CITY PLAN COMMISSION**THURSDAY, SEPTEMBER 21, 2023****FILE NUMBER:** S223-241**SENIOR PLANNER:** Sharmila Shrestha**LOCATION:** Pentagon Parkway at Tyler Street, northwest corner**DATE FILED:** August 25, 2023**ZONING:** MF-2(A)**CITY COUNCIL DISTRICT:** 4**SIZE OF REQUEST:** 1.54-acres**APPLICANT/OWNER:** Arham Opportunity Investments, LLC**REQUEST:** An application to create one 1.54-acre lot from a tract of land in City Block 5984 on property located on Pentagon Parkway at Tyler Street, northwest corner.**SUBDIVISION HISTORY:**

1:2,400	<p align="center">EXISTING AREA ANALYSIS MAP</p> <p> <input type="checkbox"/> Area of Request <input type="checkbox"/> Recent History </p>	Case no: <u> S223-241 </u> Date: <u> 9/5/2023 </u>
--	--	---

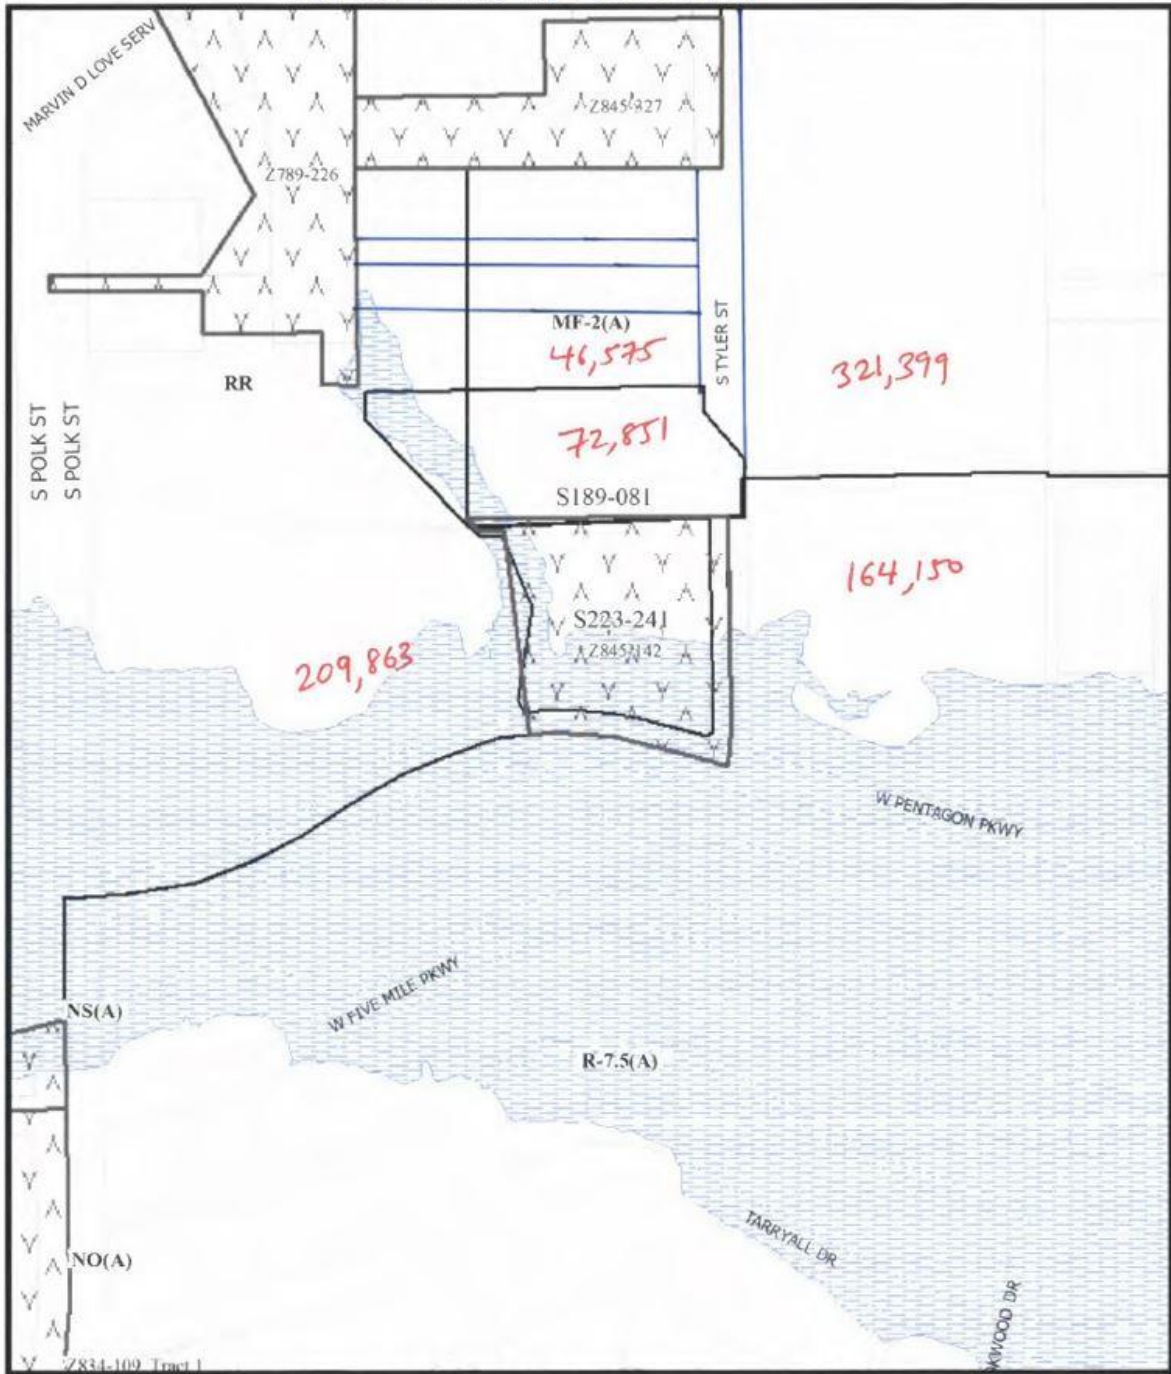
Staff finds that there is no established lot pattern within the immediate vicinity of the area (*refer existing area analysis map*); and the request is in compliance with Section 51A-8.503 and also with the requirements of the MF-2(A) Multi Family District; therefore, staff recommends approval subject to compliance with the following conditions.
